TECHNICAL STAFF REPORT

Case No./Petitioner: SDP-73-023c/Clover Acquisitions LLC c/o The Howard Hughes Corporation

Project Name: The Rouse Building Renovation for Whole Foods

<u>Subject:</u> SDP-73-023c, Columbia, Town Center, Section 1, "The Rouse Building Renovation",

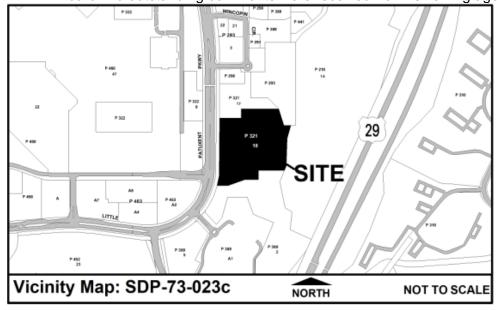
No parking shall be located within 10 feet of any lot line except as may be shown on a site development plan approved by the Howard County Planning Board. The revision to the site development plan proposes 10 parking spaces along the northern property line adjacent to Lot 17 that encroach up to 10 feet within the 10 foot parking setback.

The placement of the parking spaces within the 10 foot parking setback will not have a detrimental impact to the public welfare or impair the use of the adjacent property. At present, seven (7) spaces on adjoining Lot 17 exist within the 10 foot parking setback. Seven (7) of the proposed 10 parking spaces on the subject property that are within the 10 foot parking setback will adjoin the existing seven spaces on adjacent Lot 17 that are within the 10 parking setback. With a shared common access for Lot 17 and Lot 18 off of Little Patuxent Parkway, the general public is unaware of the location of the adjoining property line. Consequently, the essential character of the neighborhood and district will not be altered.

Adhering to the setback regulation is possible; however, the proposed parking spaces would be lost which would reduce the total parking provided, reducing it below the required parking needed per the shared parking analysis. Providing the proposed parking spaces elsewhere onsite is not practical or possible due to the existing site layout and topography. However, the proposed configuration will improve the immediate traffic flow for both Lot 18 and adjoining Lot 17, and provide improved access for the adjacent tenants to the proposed grocery merchant.

Based on the above findings, the Department of Planning and Zoning recommends that the Planning Board approve the proposed "Redline Revision" for exterior site alterations, and requested setback adjustment to allow a reduction to the 10 foot parking setback to zero feet as requested by the petitioner.
